NP-11-0044  
September 30, 2011

Subject: Exelon Nuclear Texas Holdings, LLC  
Victoria County Station  
Early Site Permit Application  
Update on Anticipated Environmental Report Revisions  
Docket No. 52-042

Markup Pages of Victoria County Station  
ESPA ER Subsections 5.2.2.1 and 5.2.4

**Figure 5.11-2 Comparison of the 1947-1989 Monthly Historical Freshwater Inflow Frequency Distribution to Similar Monthly Distributions for the Five Modeled Hydrological Scenarios used in the Bio-statistical Evaluation**

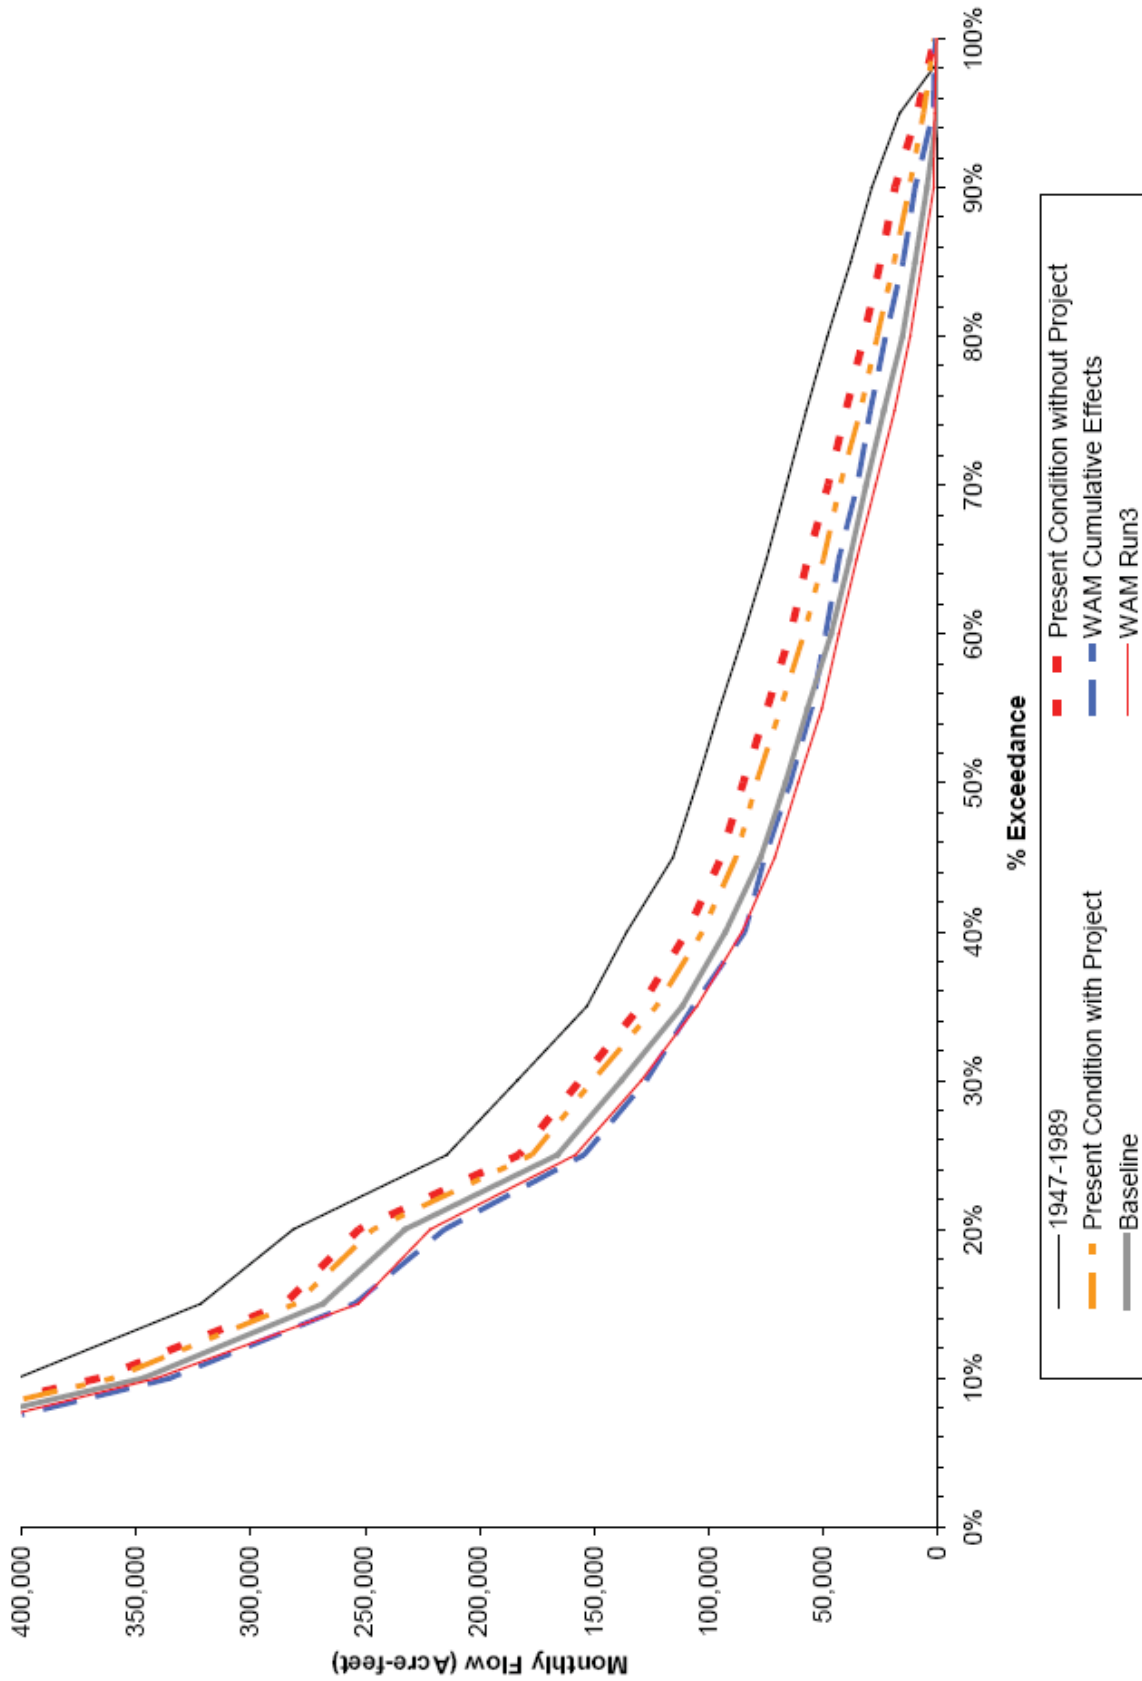
- The updated bio-statistical evaluation used two Region L WAM runs, dubbed "Region L Baseline" and "Region L Cumulative Effects", in addition to the TCEQ WAM run (Run 3) employed in the original study. Similar to TCEQ WAM Run 3, the new scenarios conservatively assume full use of existing water rights. However, these additional scenarios include different assumptions regarding return flows and upper basin operations, providing a broader characterization of possible future hydrological conditions in the GSA basin.
- Additional detail has been presented to facilitate the reader's understanding of the statistical significance of the study findings.

Figure 5.11-2 provides a comparison of the historical frequency distribution of monthly freshwater inflows to San Antonio Bay with similar distributions generated using the five modeled hydrological scenarios (Present Conditions without and with VCS, Region L Baseline, Region L Cumulative Effects, and TCEQ WAM Run 3) used in the bio-statistical evaluation. The relatively tight pairing of the lines depicting the Present Conditions without VCS and Present Conditions with VCS scenarios demonstrates the relatively small impact that operation of VCS would have on monthly inflows to the bay (see Subsection 5.2.2.1) compared to the modeled present demand. The comparatively larger gap between the lines representing the Present Conditions without VCS scenario and the three full utilization scenarios indicates that the bulk of reductions of inflows to the San Antonio Bay system results from full utilization of existing water rights. This observation is consistent with the findings of the cumulative effects analysis conducted in the Region L 2011 Regional Water Plan, as summarized earlier in Subsection 5.11.3.2.
